DEVELOPMENT APPLICATION ASSESSMENT REPORT

Responsible Officer:	Olivia Ramage	
Land to be developed (Address):	Lot 5C DP 13374, 1056 Barrenjoey Road PALM BEACH NSW 2108	
Proposed Development:	Alterations and additions to a dwelling house	
Zoning:	C4 Environmental Living SP2 Infrastructure

DA2021/2537

Figure 1 - North Side Boundary Envelope

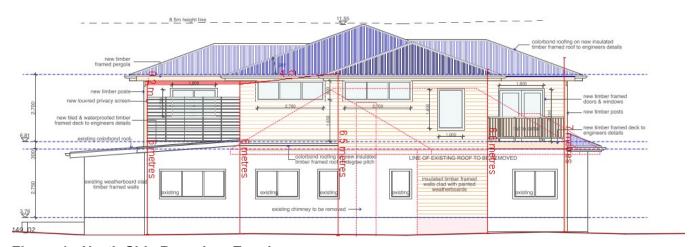
The proposed development results in an encroachment on the northern side boundary between nil and 0.2m (0-5.7%) for a length of 4.8m. On the southern side boundary there is an encroachment of 0.55m (15.7%) for a length of 17.07m.

The bulk and scale of the proposed development has been reduced as the first floor has been stepped in from the northern boundary to significantly decrease the envelope encroachment. The addition of a deck at the front and the rear along the northern side of the dwelling reduces the bulk of the dwelling. The dwelling complies with the height controls as well as the side setback controls which ensures bulk and scale is reduced.
